DEPARTMENT OF THE NAVY

Subj: Securing Ex-Saratoga Aircraft Elevators 1, 2, 3, and 4 At The Flight Deck To Keep Platforms Secure and Stable While Relocating Ship And During Removal and Disposal of Wire Ropes on Hydraulic Engines in Machinery Spaces.

Ref: (a) NAVSEA Dwg 1308067E, Airplane Elevator No. 1 General Arrangement of Platform Locking Gear
(b) NAVSEA Dwg 1308068F, Airplane Elevator No. 2 General Arrangement of Platform Locking Gear
(c) NAVSEA Dwg 1323671C, Airplane Elevator No. 3 General Arrangement of Platform Locking Gear
(d) NAVSEA Dwg 1308072D, Airplane Elevator No. 4 General Arrangement of Platform Locking Gear

DETAILS FOR SECURING AIRCRAFT ELEVATOR 1, 2, 3, AND 4 FWD AND AFT LOCKBARS IN THE ENGAGED POSITION FOR TOWING SHIP. MINOR DEVIATIONS TO ACCESS CUTS AND INSTALLATION OF LOCKBAR SPACER AND BULKHEAD PLATE IS PERMISSIBLE PROVIDED RESULTS YIELD AS GOOD OR BETTER PERMANENT SECURING OF LOCKBARS.

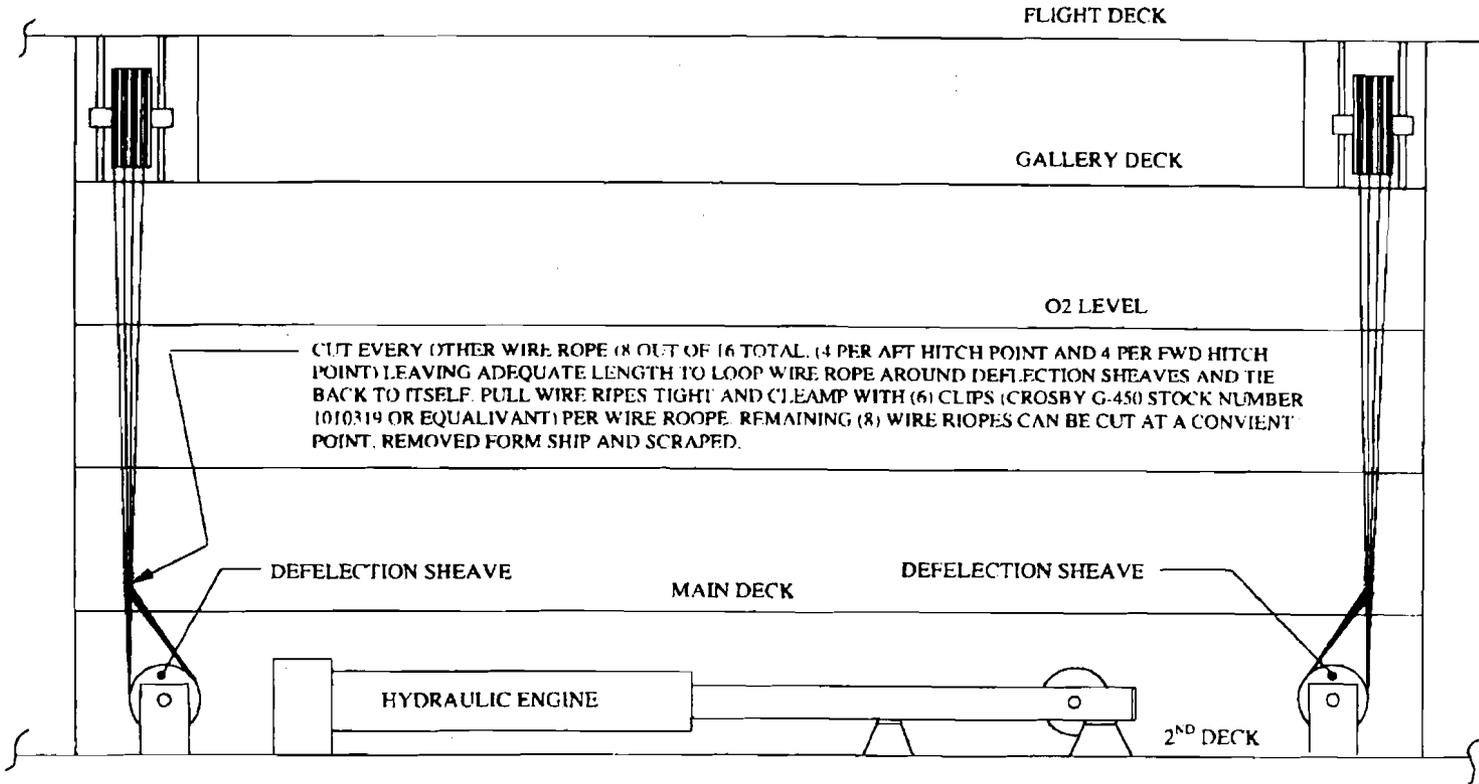
5.1 Ensure each respective aircraft elevators' fwd and aft lock bars are extended, (jack to increase engagement if necessary), and has 3" to 3-1/2" of engagement into each respective platform socket. Using OSS material and sketch provided on sheet 4 of this document, fit up and weld spacer and bulkhead plates in place to permanently secure each lock bar in the engaged position. Clean all areas to be welded to bare metal. Welding and visual inspection of completed welds shall be in accordance with MIL-STD-1689. See NNSY Corporate Weld Procedure WP-1689 Welding Technique Sheet (Enclosure 1) for welding guidance. Note: If problems are

encountered with preheating of ships structure for welding, it is permissible to use 309 filler material (which requires no preheating).

DETAILS FOR CUTTING AND TYING OFF AIRCRAFT ELEVATOR PLATFORM WITH HALF OF EXISTING WIRE ROPES AND CUTTING/SCRAPPING REMAINING WIRE ROPES. APPLIES TO 1, 2, 3, AND 4 AIRCRAFTE ELEVATORS

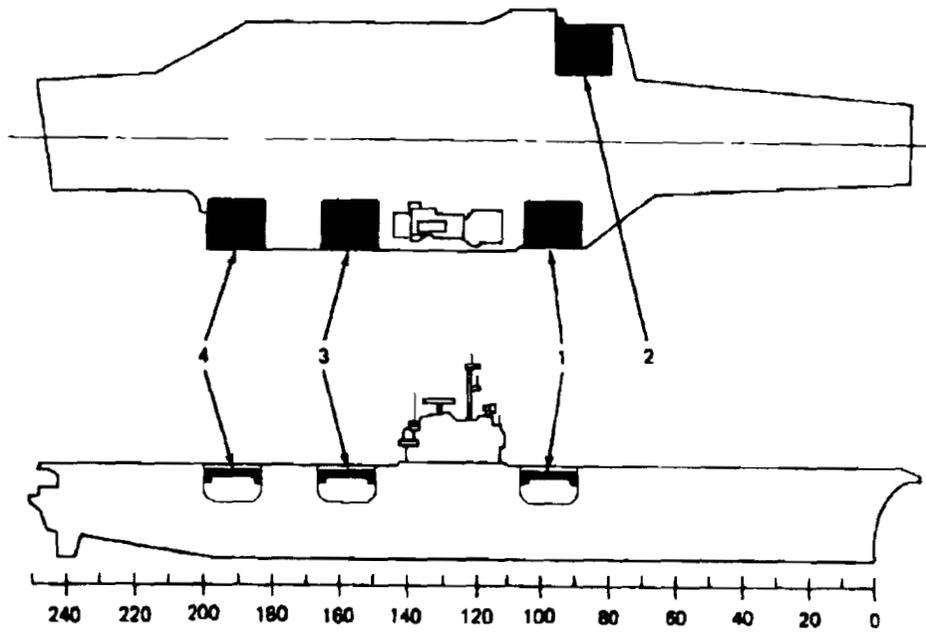
5.2 After each lock bar has been secured in place, cut wire ropes in each respective machinery space leaving an adequate length on every other wire rope (i.e., 4 out of 8 wire ropes on fwd and 4 out of 8 wire ropes on aft end of machinery space) to loop around each respective deflection sheave and tie back to themselves. Clamp in accordance with sketch and notes provided on sheet 5 of this document. Cut length of remaining wire ropes (i.e., 4 on fwd end and 4 on aft end of machinery space) to any length desired for ease of handling and scrapping.
